CERTIFICATE OF APPROPRIATENESS

Property: 1213 Harvard Street, Lot 9, Block 187, Houston Heights Subdivision. The property includes an altered historic 3,180 square foot, two-story wood frame single-family residence with a new two-story addition and a new two-story garage under construction. The structures are located on a 6,600 square foot (50' x 132') interior lot.

Proposal: Alteration – Addition/Garage Revision

Recommendation: Partial Approval:

SOUTH SIDE ELEVATION
EXISTING PRIOR TO CONSTRUCTION

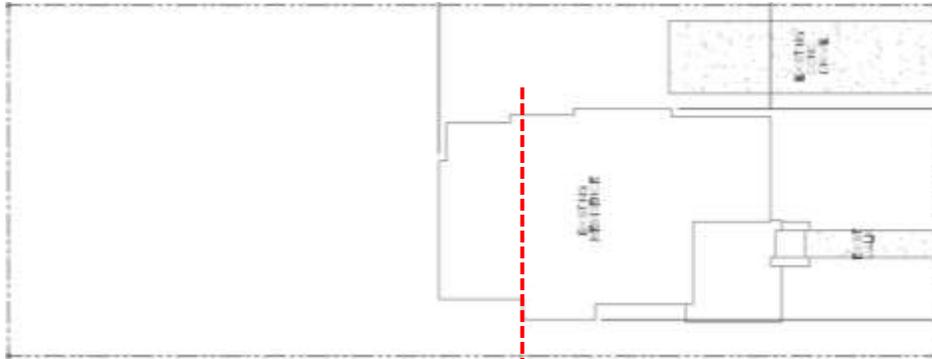
(South) Addition: Add a 2' 6" tall by 2' 6" wide fixed window to the first floor of the proposed stairwell. Omitted a pair of adjoining windows and replaced them with two 5' 9" tall by 2' 9" wide windows separated by approximately 8'. Add a 5' wide fireplace flue at the approved rear screened porch. The flue will be sided in wood cladding matching the addition. Add a 5' tall by 4' wide fixed window at the second story of the stairwell. Shifted a pair of approved windows at the second floor den closer to the front of the property. Added a pair of 1' 9" by 1' 9" fixed windows at the second floor bathroom.

Garage apartment: Garage will be attached to the main residence by a 9' 2" deep breezeway. A 3' tall by 2' 6" wide window will be added to the second floor landing of the living space above the garage.

- 1. Approve the revisions to the fenestration on the north and south side of the addition.
2. Approve the breezeway connector between the garage and the rear of the house.
3. Deny the removal of one original historic window, enlargement of the original opening, and installation of a pair of new windows on the historic portion of the house.

SITE PLAN

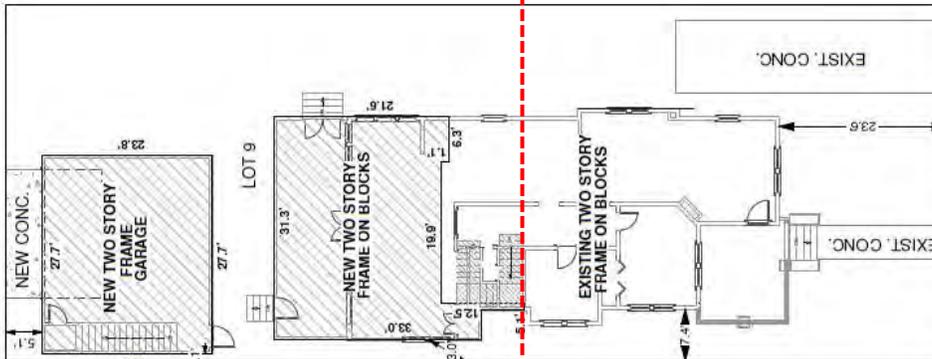
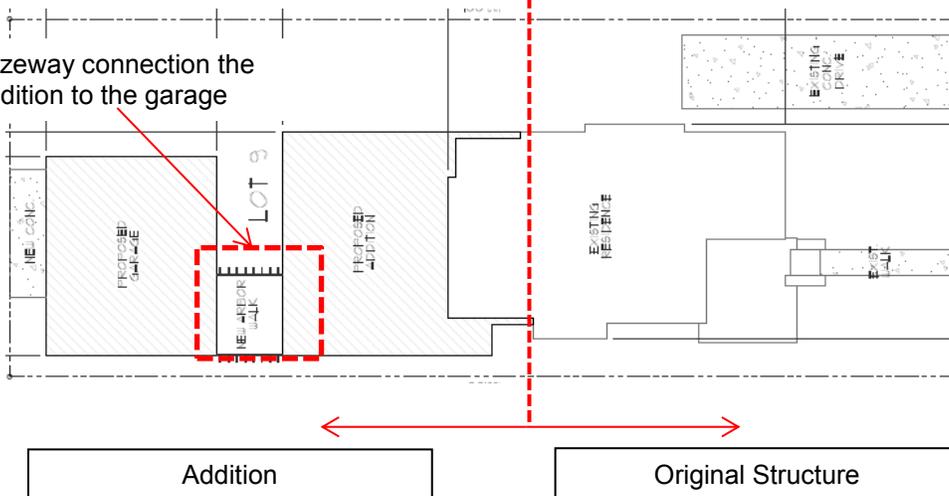
Shape/Mass: The applicant has been granted two COAs to construct a two story rear addition and one for a two story detached garage/apartment behind the addition. The applicant now requests approval to connect the addition to the garage apartment by a 9' 2" deep by 11' 1" wide wood breezeway.

Garage apartment: Garage will be attached to the main residence by a 9' 2" deep breezeway. A pair of 5' 9" tall by 3' wide windows will be added flanking a pair of single lite French doors on the first floor. The second floor will feature two 5' 9" tall by 3' wide windows.

FIRST FLOOR PLAN
EXISTING PRIOR TO CONSTRUCTION

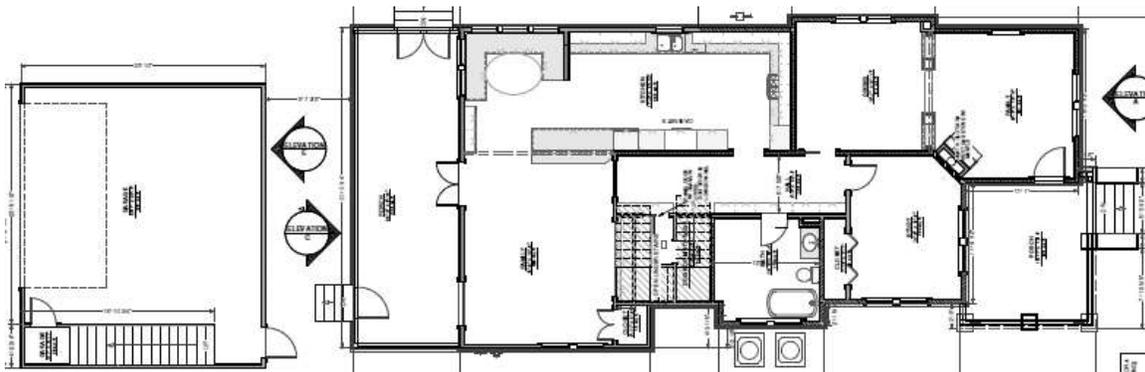
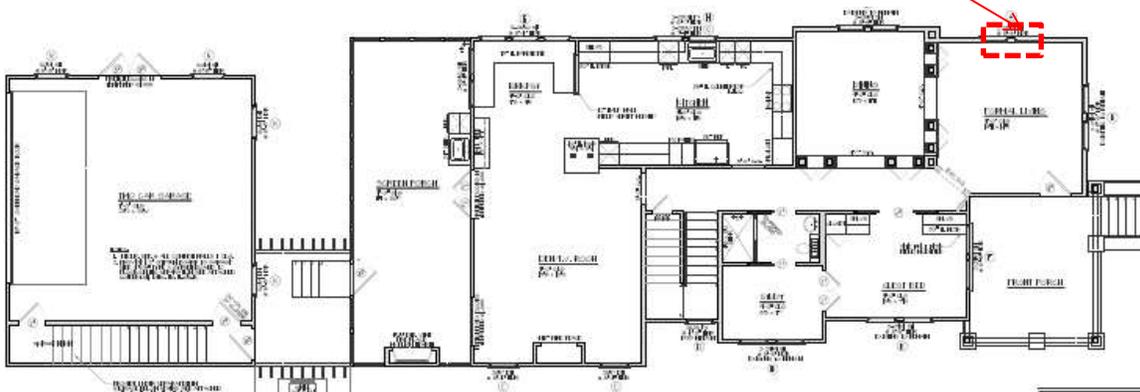
Altered original window opening

Windows/Doors: Historic Structure: Remove an original undamaged approximately 3' wide historic wood 1-over-1 window and trim. Install a pair of new wood 1-over-1 windows. The pair of windows measure 5' 9" tall by 5' wide which necessitated the removal of the surrounding trim and wall material to enlarge the window opening.
